BMP NUMBER: YC022

Stormwater Management/BMP Record Drawing and Construction Certification Review Tracking Form

County Plan No.: SP-74-04
Project Name: CHESAPEAKE BANK - LIGHTFOOT (NOVANO PROPERTY)
Stormwater Management Facility: BIORETENTION BASIN

Designed AES	Drawn AES
Scale 1" = 20'	Date 6/07/04
Project No. 9354-01	
Drawing No. 4

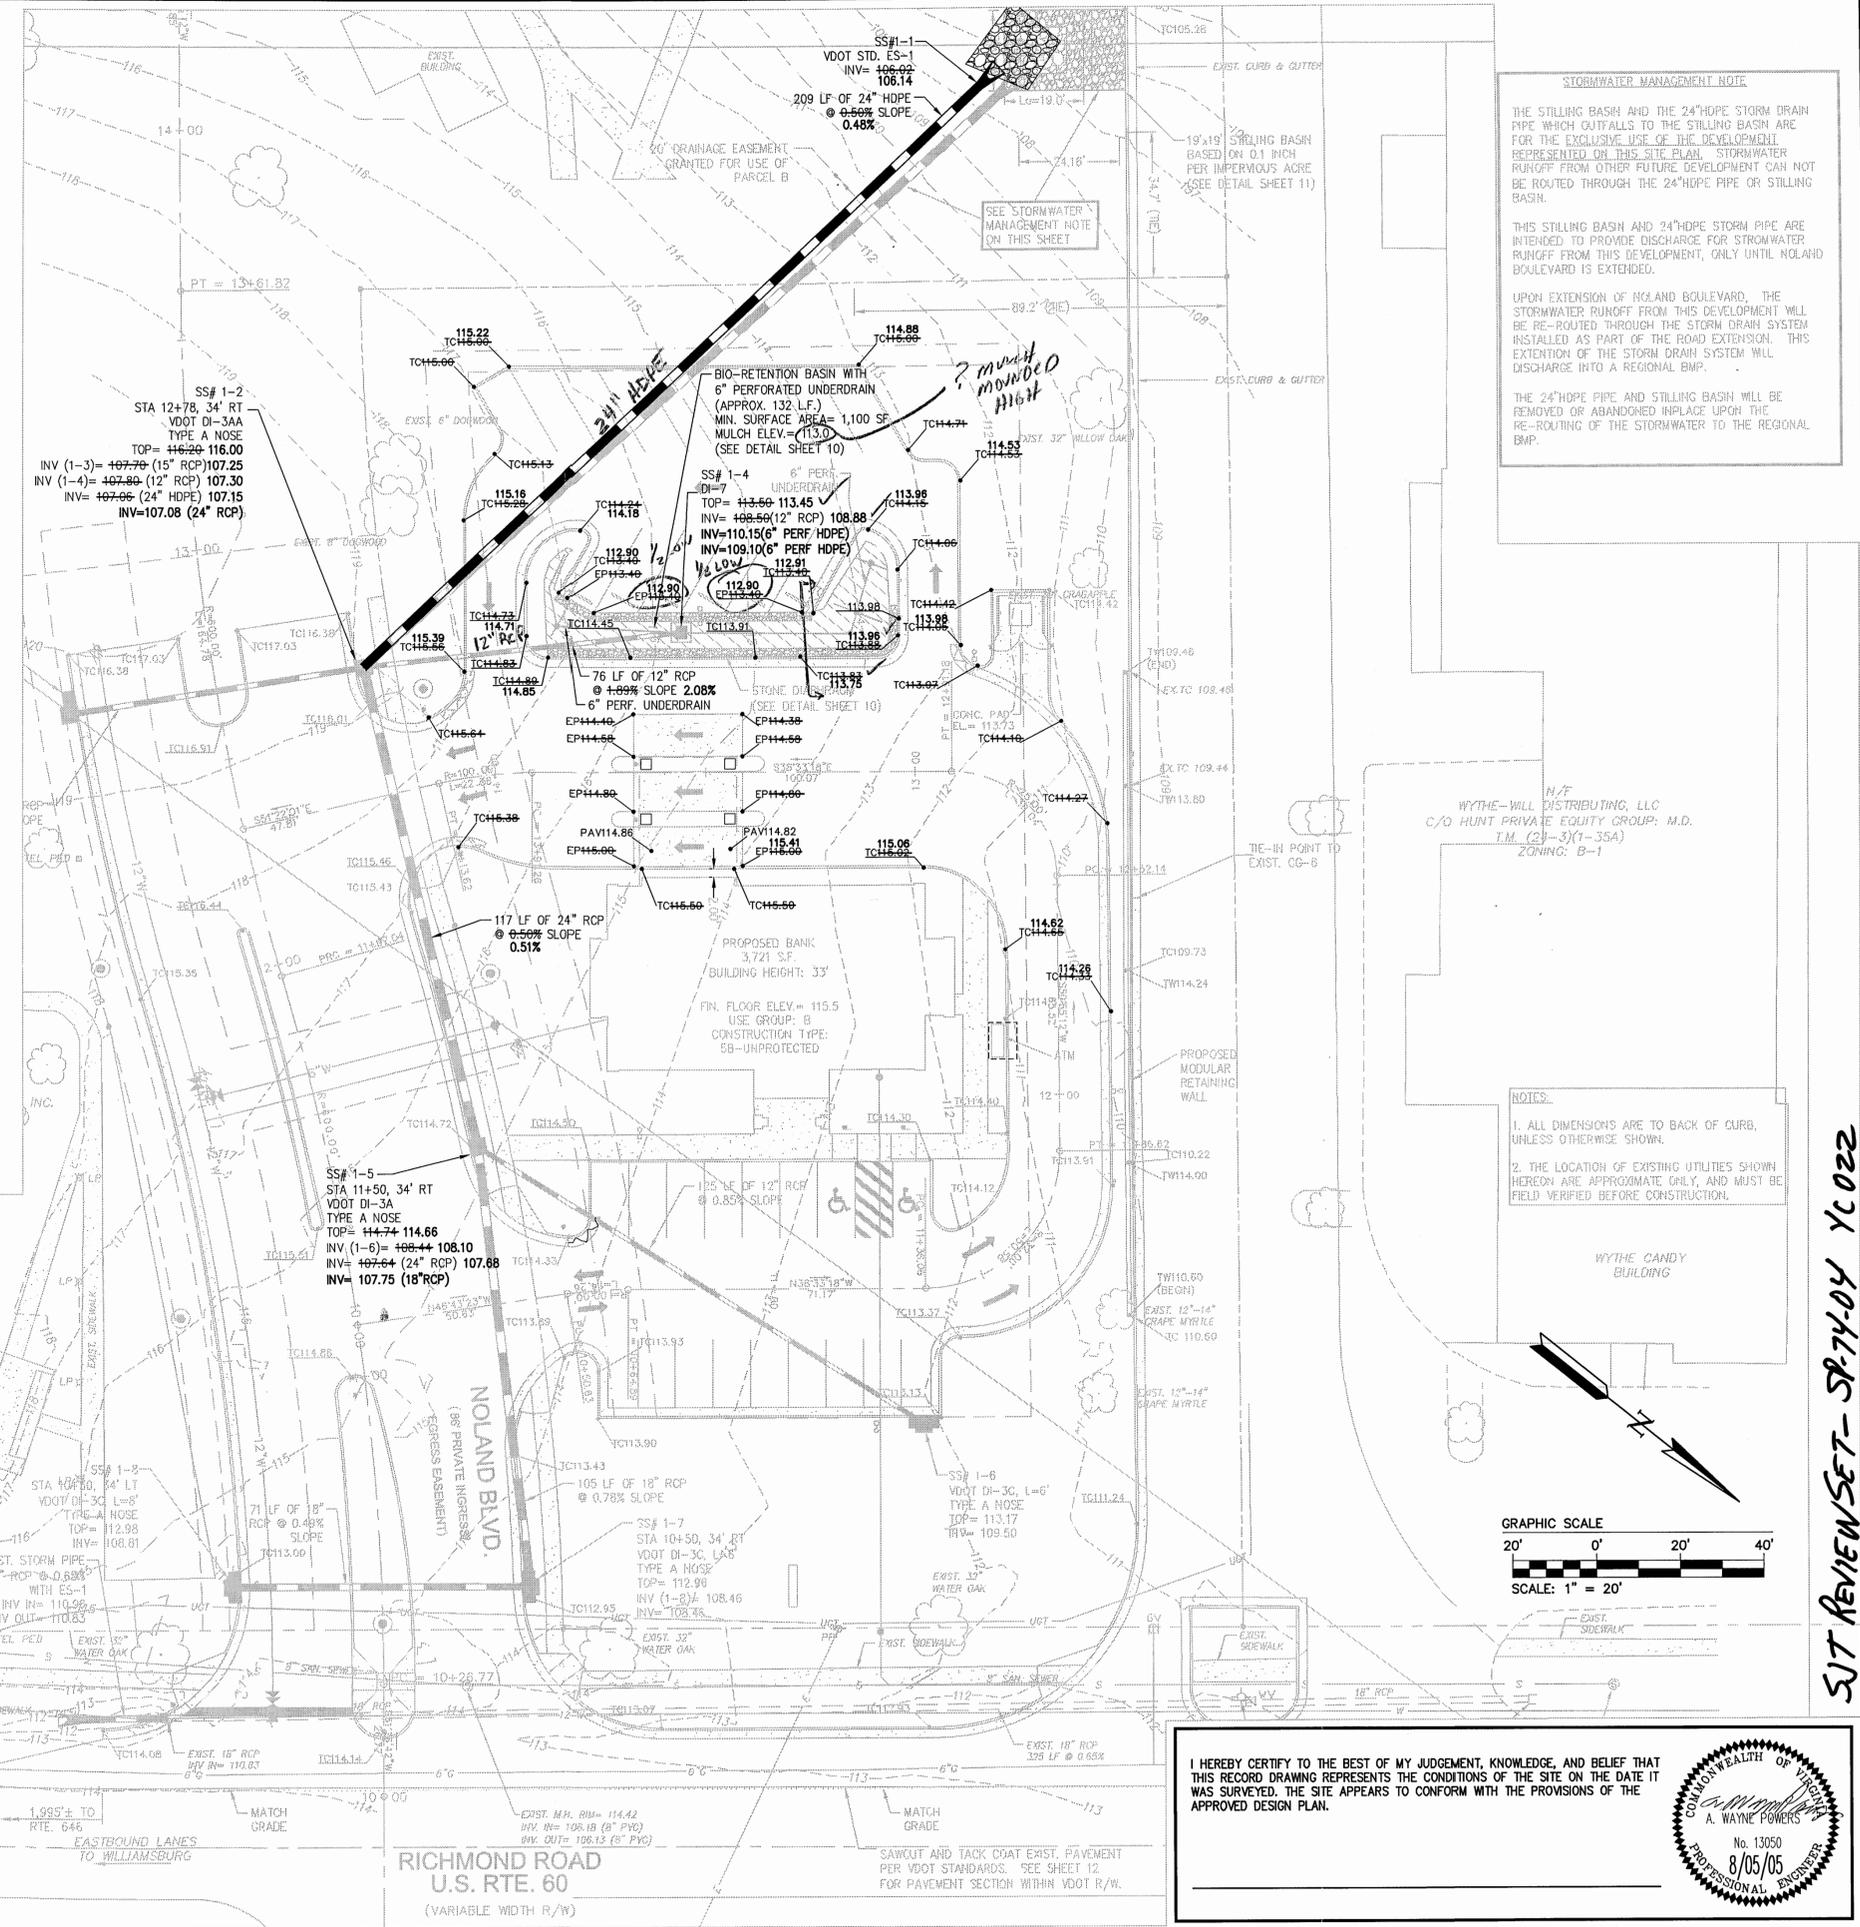
- XX 16. Outfall protection dimension, type and depth of rock and if underlain filter fabric is present. **Stilling Basin is undersized from Plans, but is performing adequately.**

- XX SD1. All requirements of Section II, Minimum Standards, apply to Storm Drainage Systems.
- XX SD2. Horizontal location of all pipe and structures relative to the SWM/BMP facility.
- XX SD3. Type, top elevation and invert elevation of all access type structures (inlets, manholes, etc.).
- XX SD4. Material type, size or diameter, class, invert elevations, lengths and slopes for all pipe segments.
- XX SD5. Class, length, width and depth of riprap and outlet protections or dimensions of special energy dissipation structures. **Stilling Basin is smaller than designed, but seems to be performing adequately.**

SECTION A-A STILLING BASIN DETAIL N.T.S.

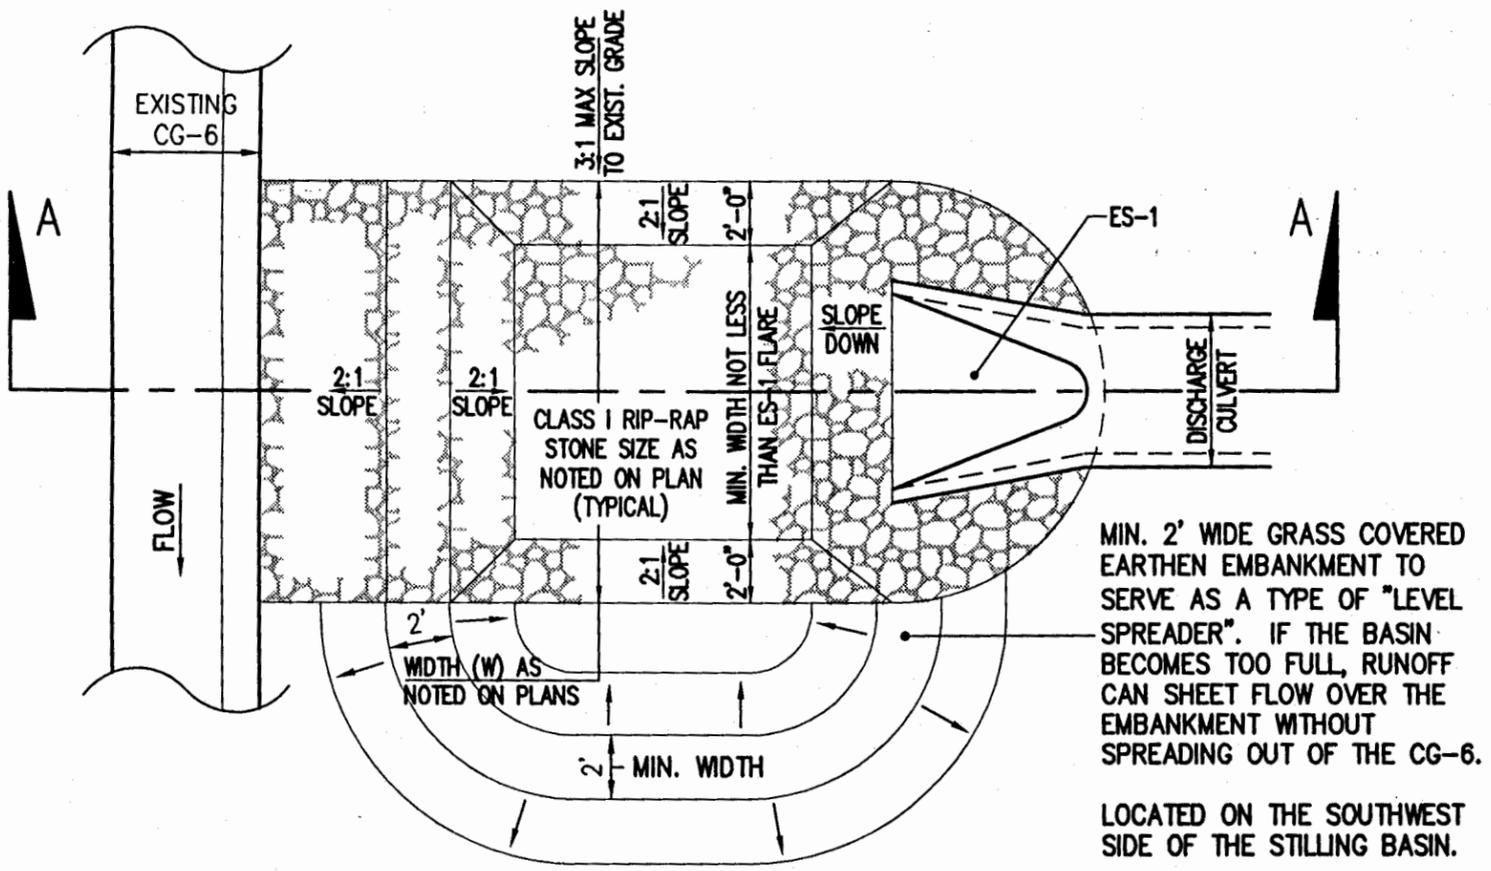
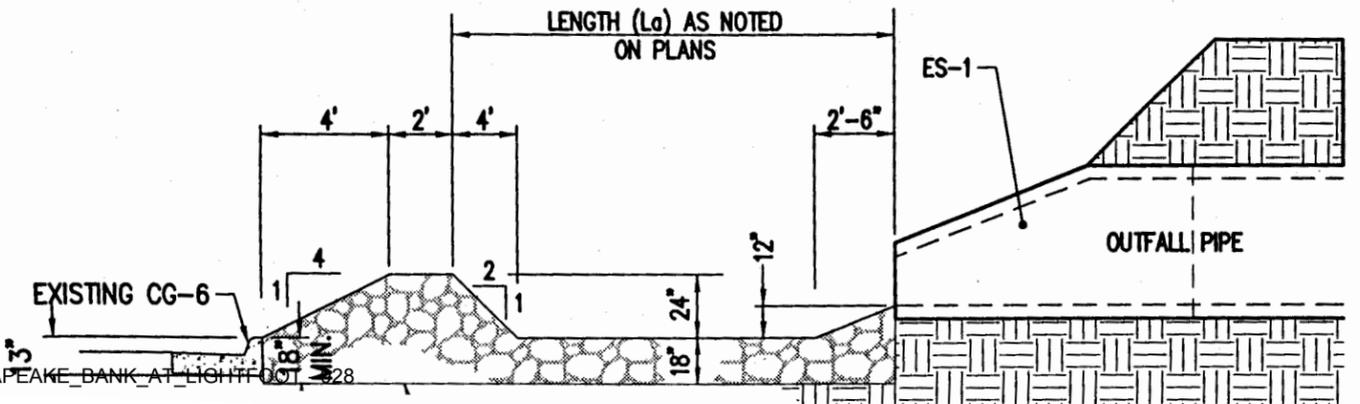
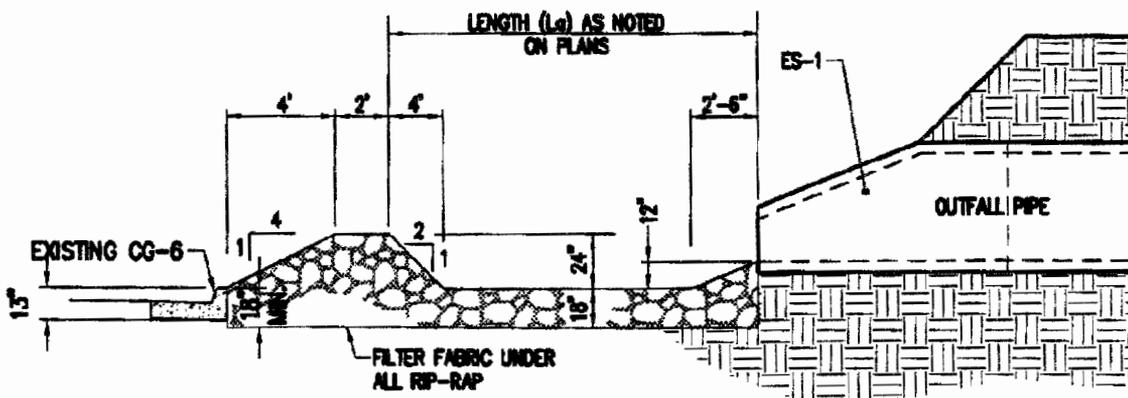
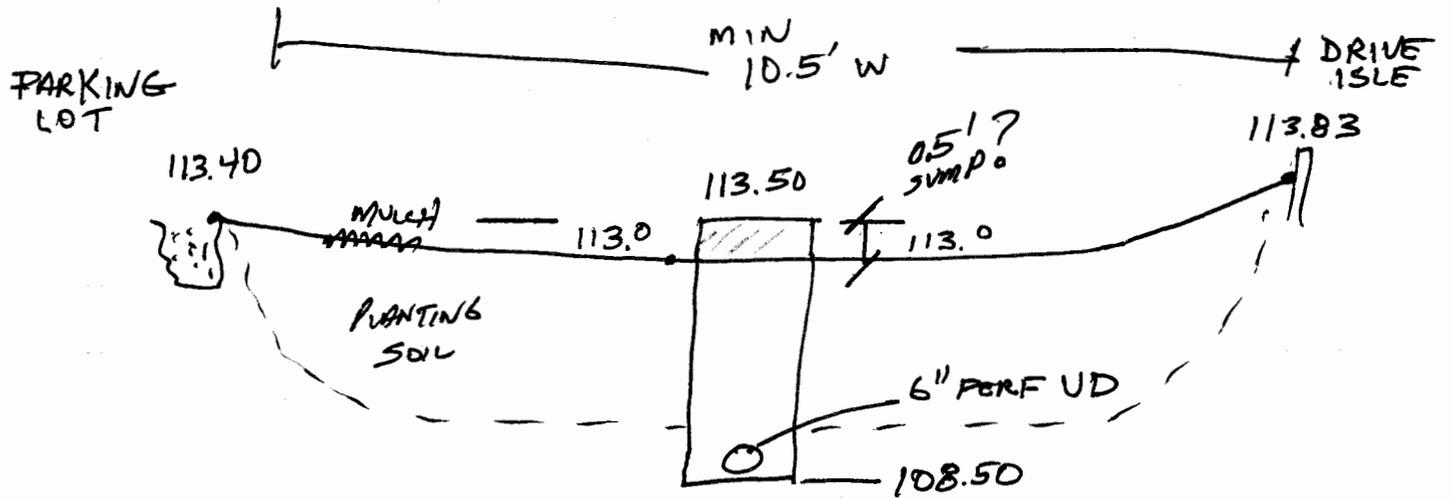
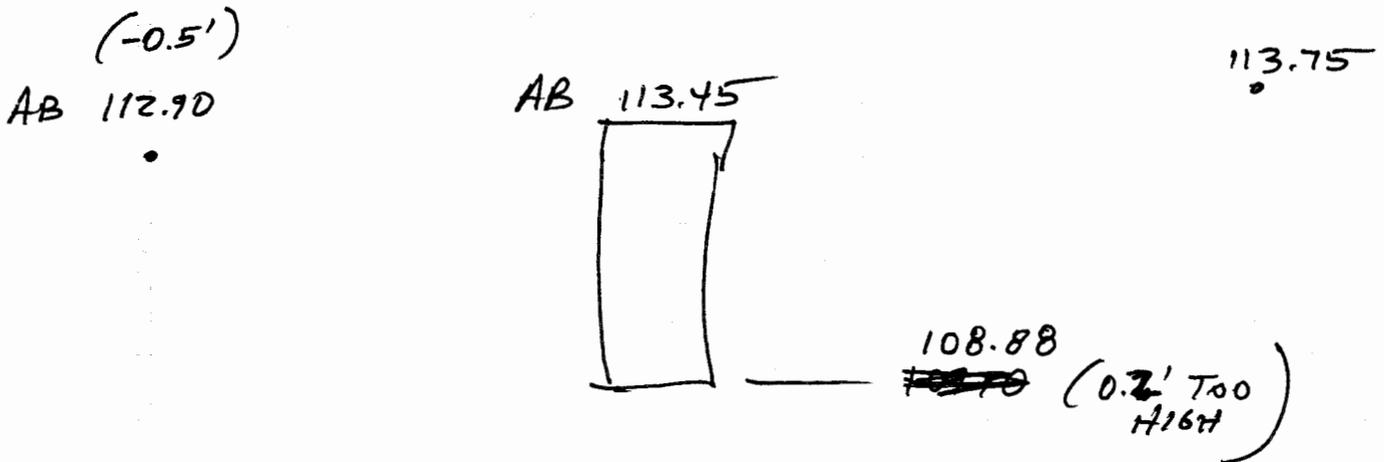
As a follow-up to your on-site meeting with Mark Bennett last Thursday 10/07/04, the attached 2 sheets reflect the additions to the site plan discussed with Mark. Sheet 4 contains a note, which specifies that the Stilling Basin and outfall to the stilling basin are for the exclusive use of this site development only, and that the stilling basin and outfall pipe will be abandoned/removed when the road is extended. Sheet 10: The Stilling Basin Detail has been modified to show a small earthen mound on the down slope side of the stilling basin.

1. Label storm drain outfall SS # 1-1 on Sheet 4 as temporary, to be removed with extension of storm drainage piping along Noland Boulevard.
2. Rearrange the spreader lip portion of the stilling basin so that it is constructed on the north (Wythe-Will) and west side of the basin. Revise plan Sheet 4 and/or the detail on Sheet 10 appropriately. Overflow from the stilling basin should not be able to short-circuit around the west side.

2. Rearrange the spreader lip portion of the stilling basin so that it is constructed on the north (Wythe-Will) and west side of the basin. Revise plan Sheet 4 and/or the detail on Sheet 10 appropriately. Overflow from the stilling basin should not be able to short-circuit around the west side.

MIN. 2' WIDE GRASS COVERED EARTHEN EMBANKMENT TO SERVE AS A TYPE OF "LEVEL SPREADER". IF THE BASIN BECOMES TOO FULL, RUNOFF CAN SHEET FLOW OVER THE EMBANKMENT WITHOUT SPREADING OUT OF THE CG-6.

LOCATED ON THE SOUTHWEST SIDE OF THE STILLING BASIN.

GRADE THE TOP OF THE EMBANKMENT LEVEL WITH THE TOP OF THE CG-6 CURBING.
